RE: Service of Notice of Violation / Cease and Desist Order, Number: IO-190110-1

NOTICE OF VIOLATION / CEASE AND DESIST ORDER NUMBER: IO-190110-1

IN THE MATTER OF: PROWERS AGGREGATE OPERATORS, LLC
 CDPS GENERAL PERMIT NO. COG500000
 CERTIFICATION NO. COG501574
 and UNPERMITTED
 PROWERS COUNTY, COLORADO

ATTACHMENT A

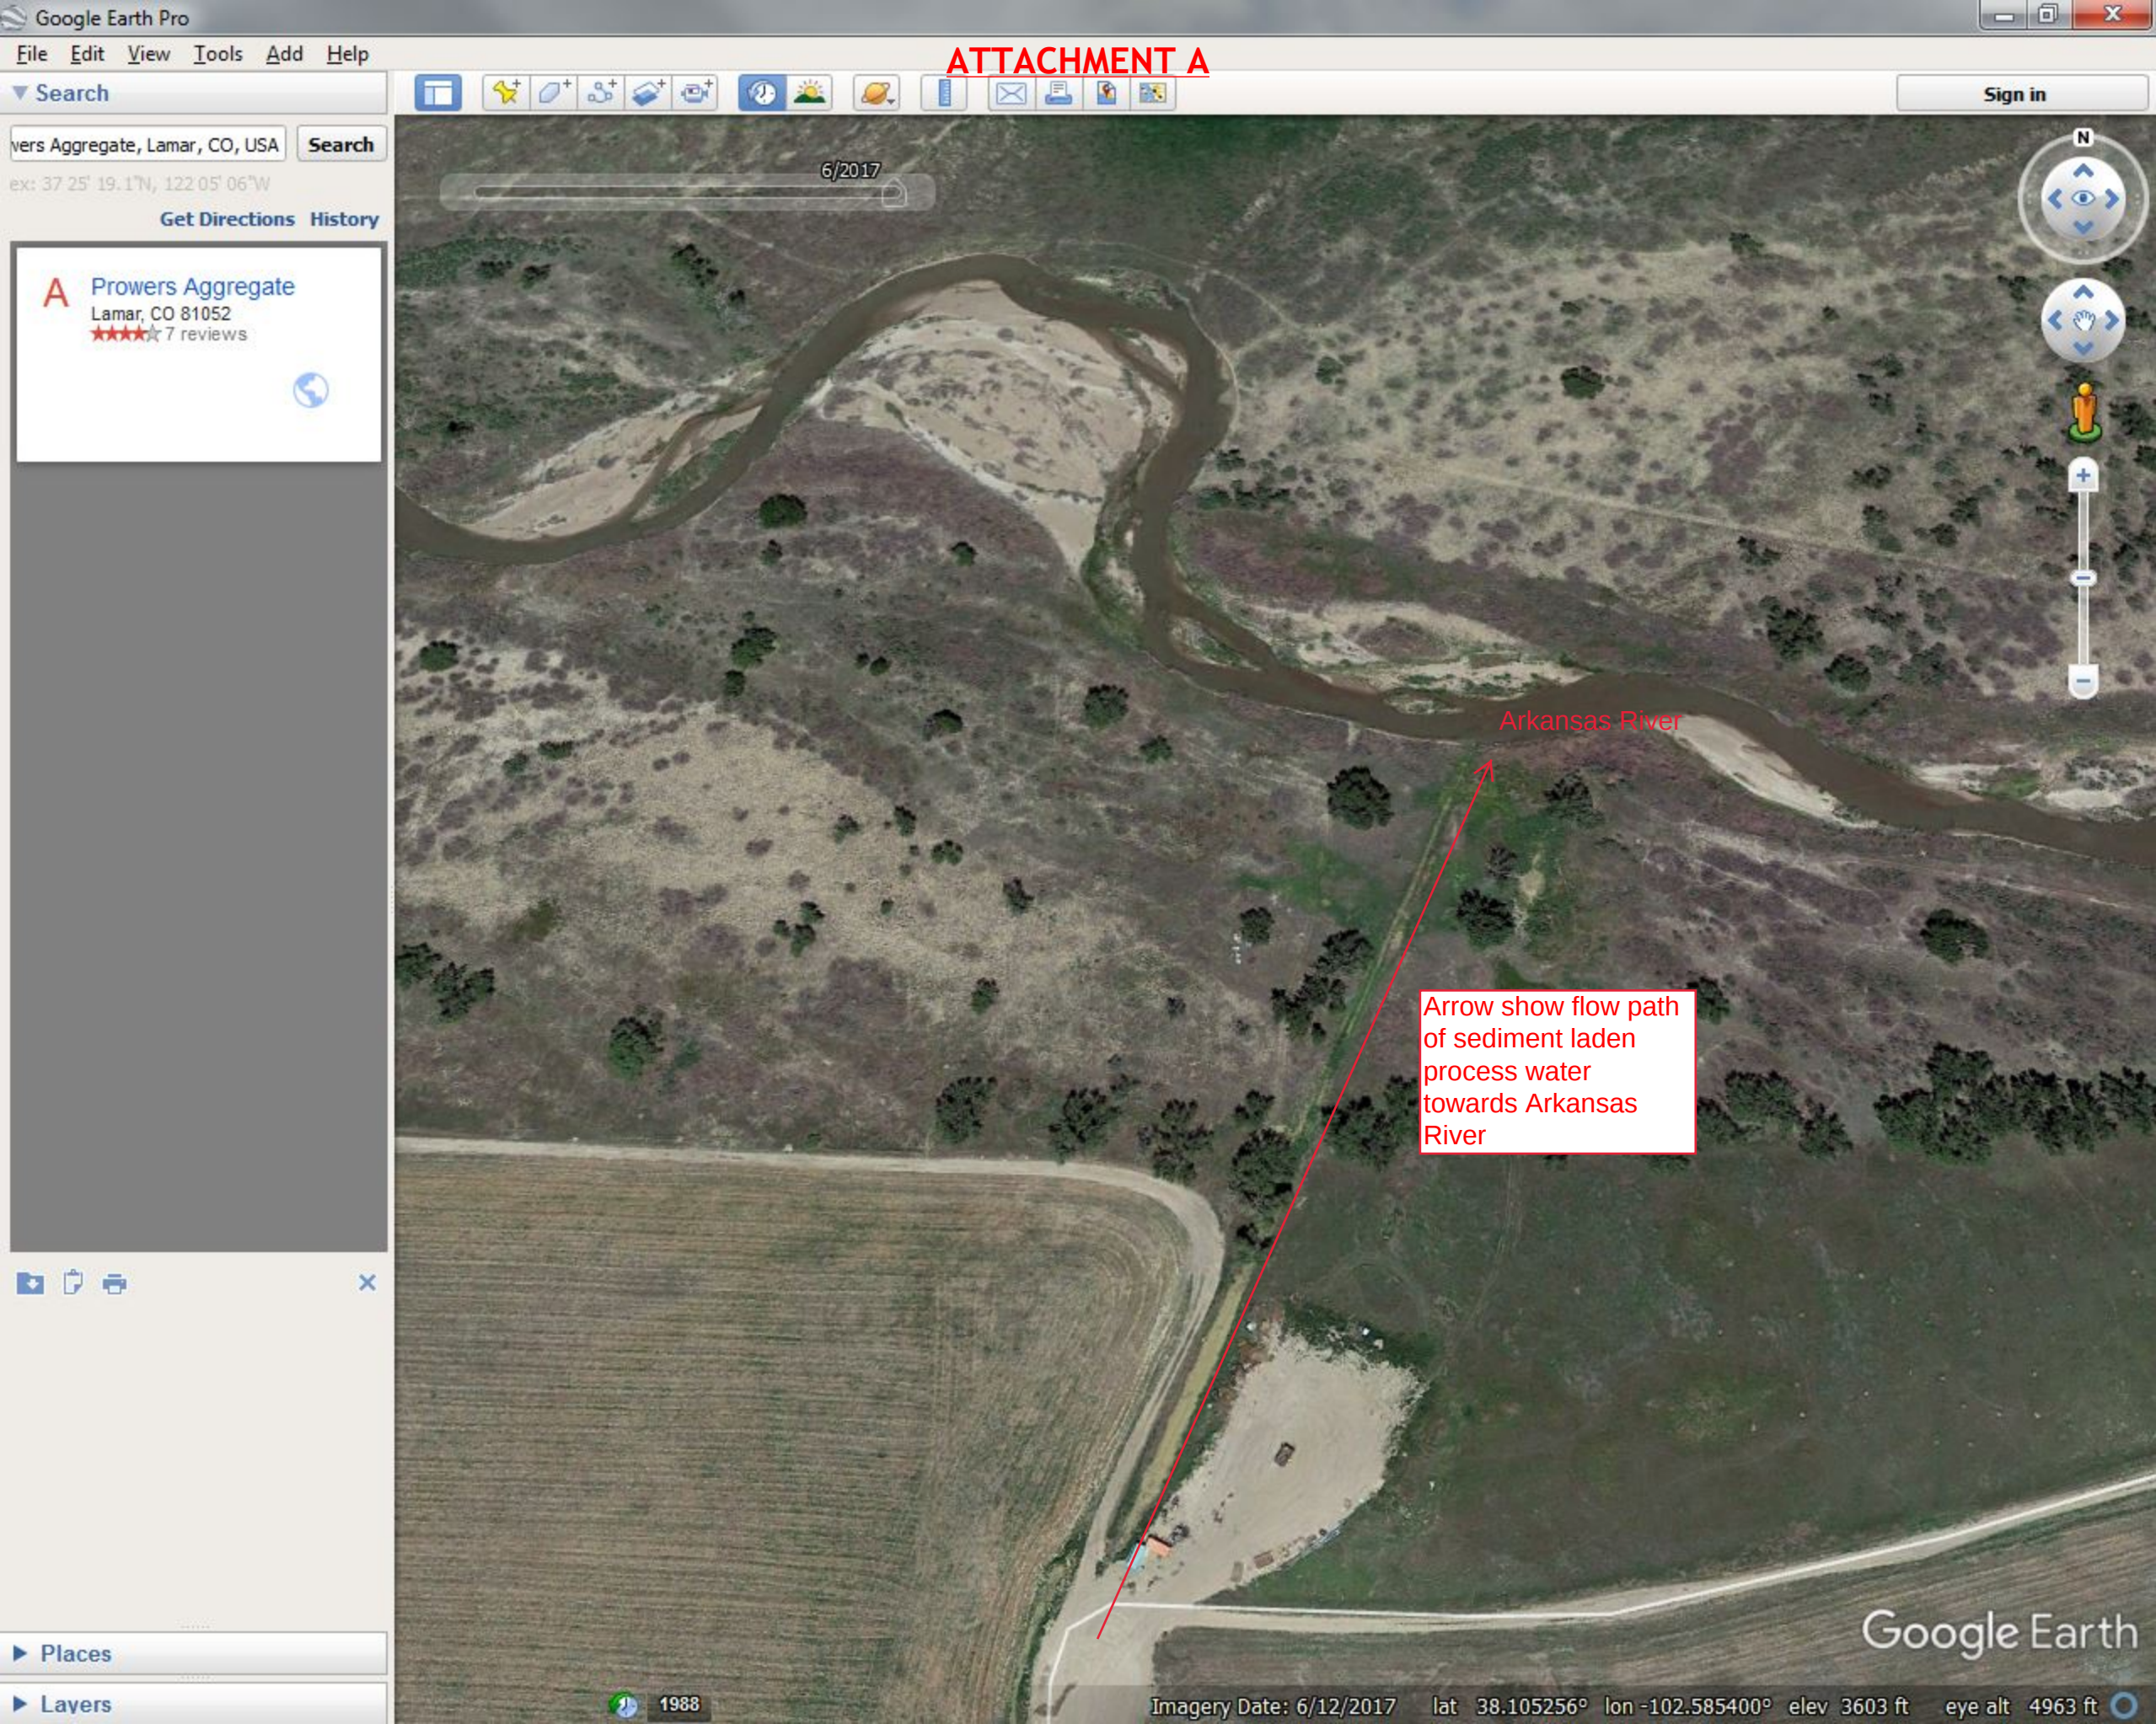
Active pumping from pond into roadside ditch.

ATTACHMENT A

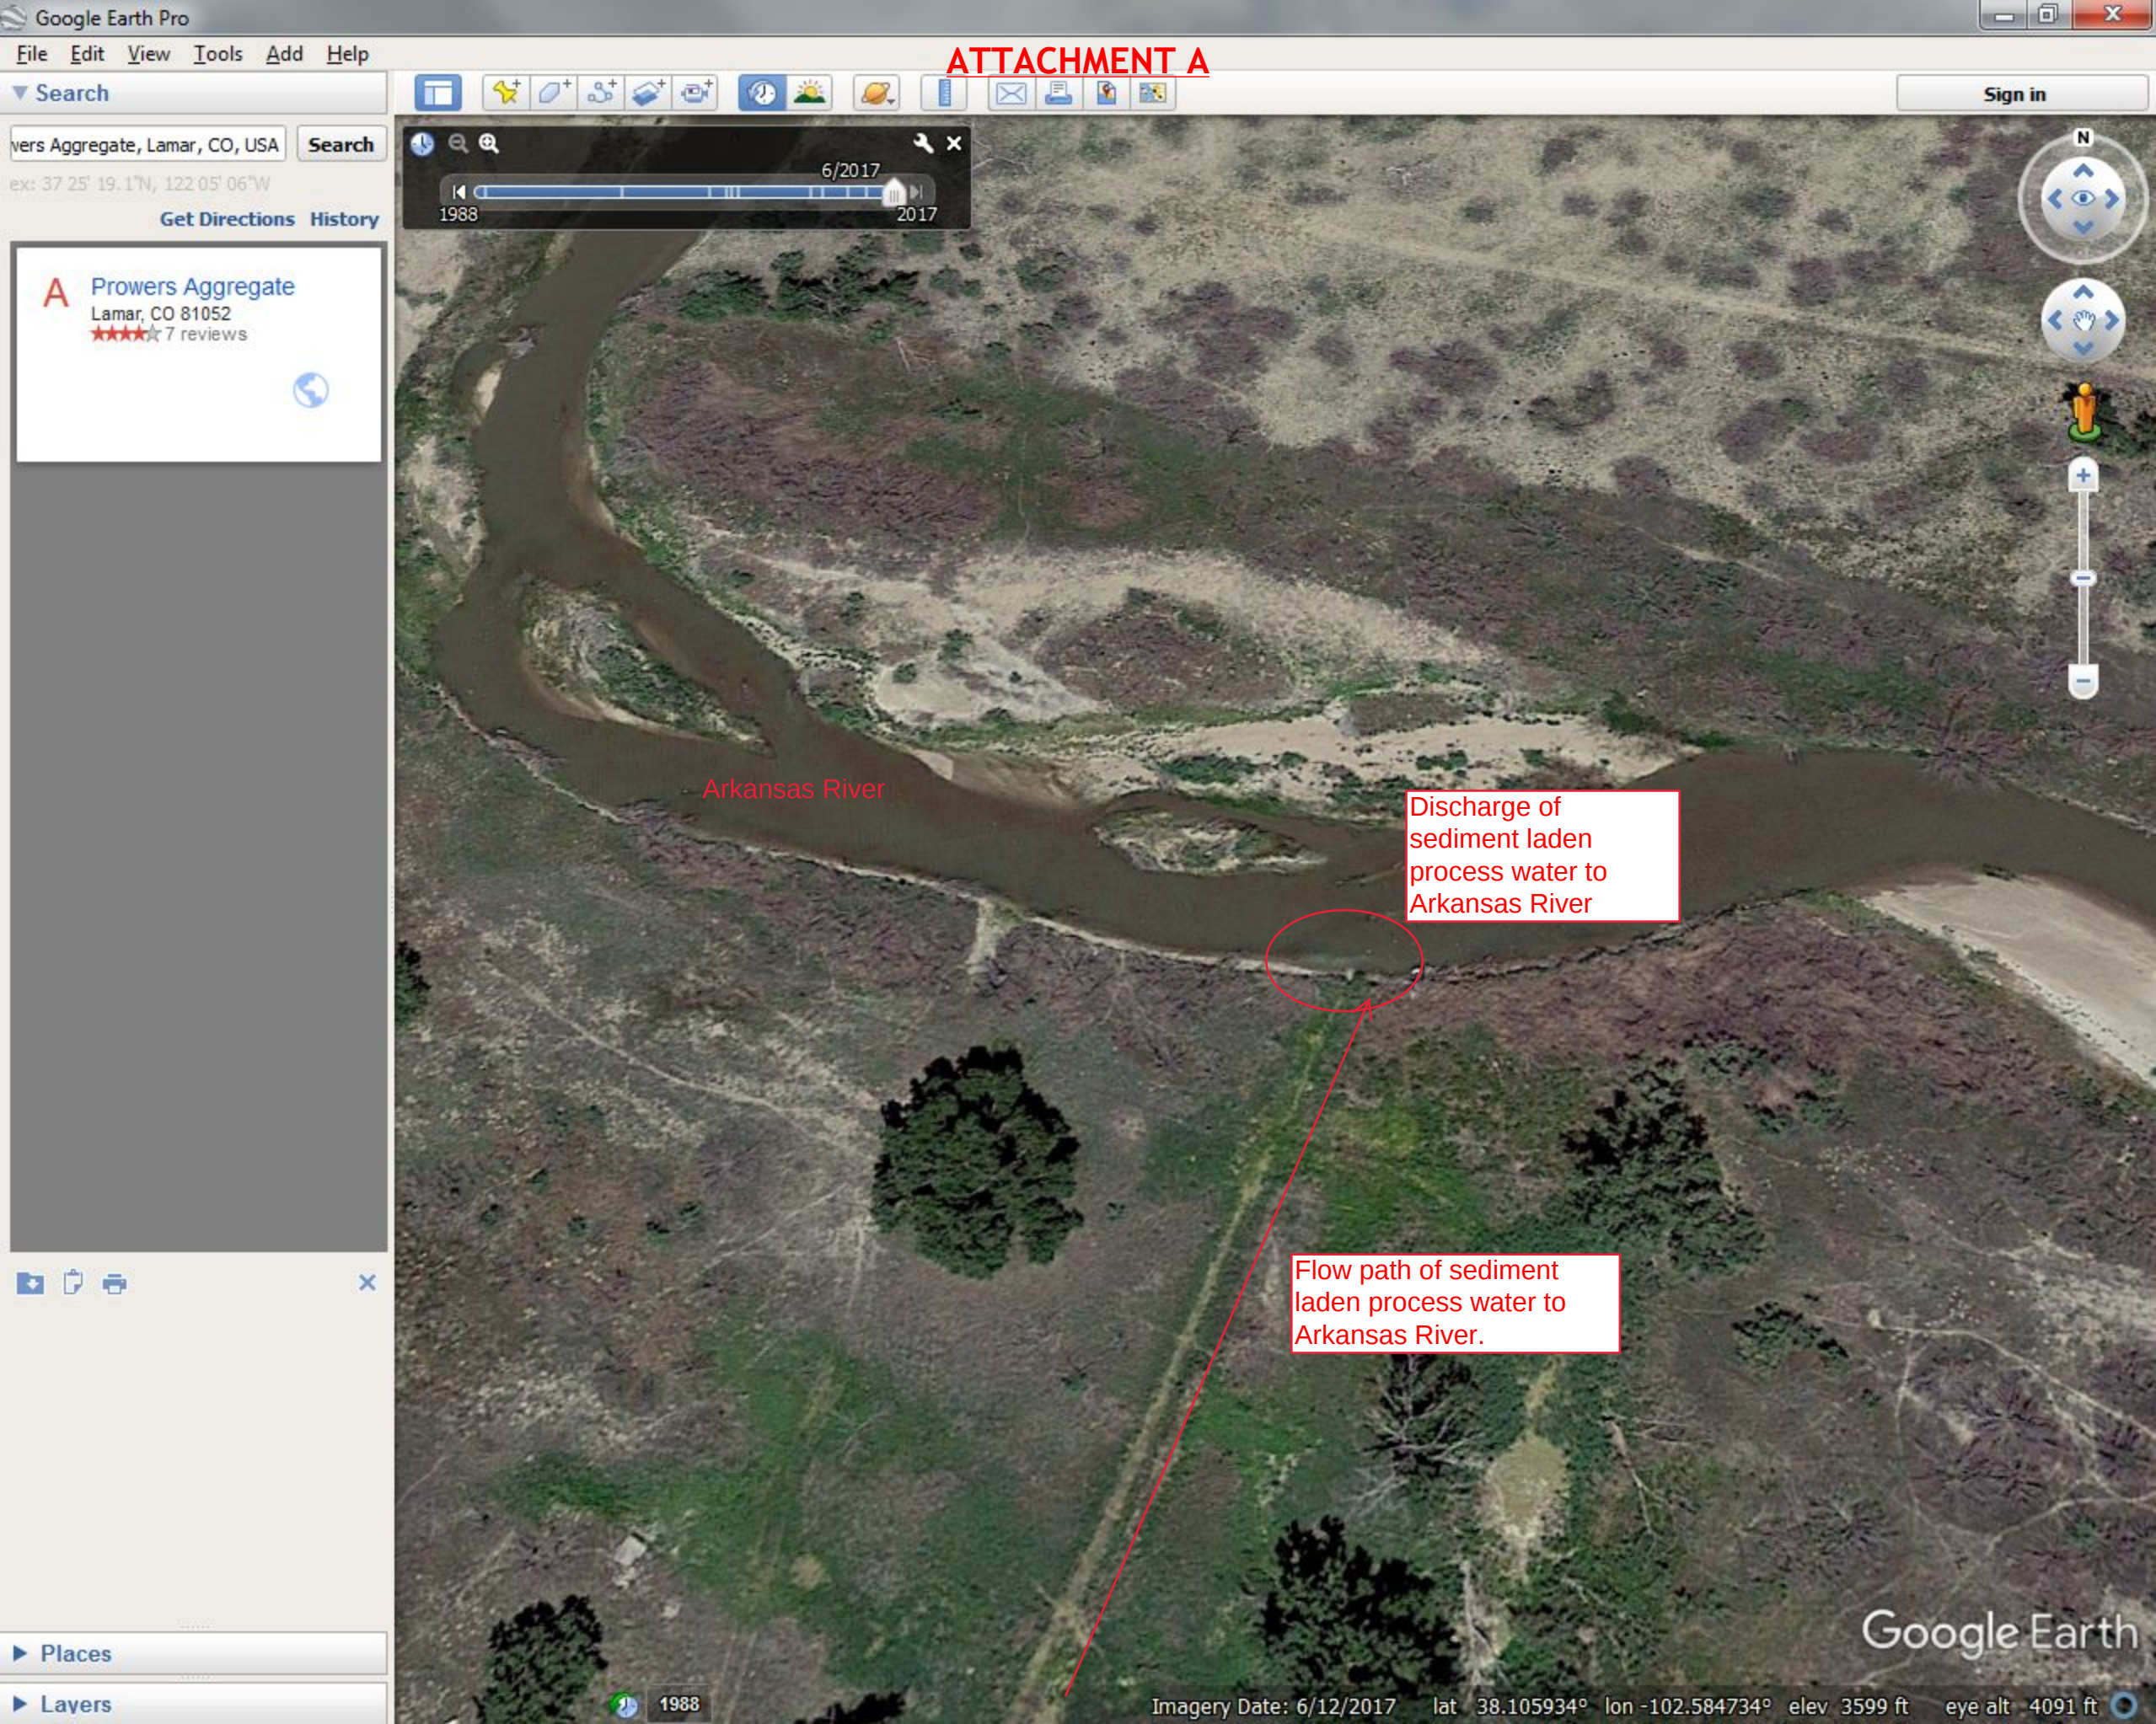
Flow path of roadside ditch towards Arkansas River. Sediment laden water can be seen in roadside ditch to left of arrow.
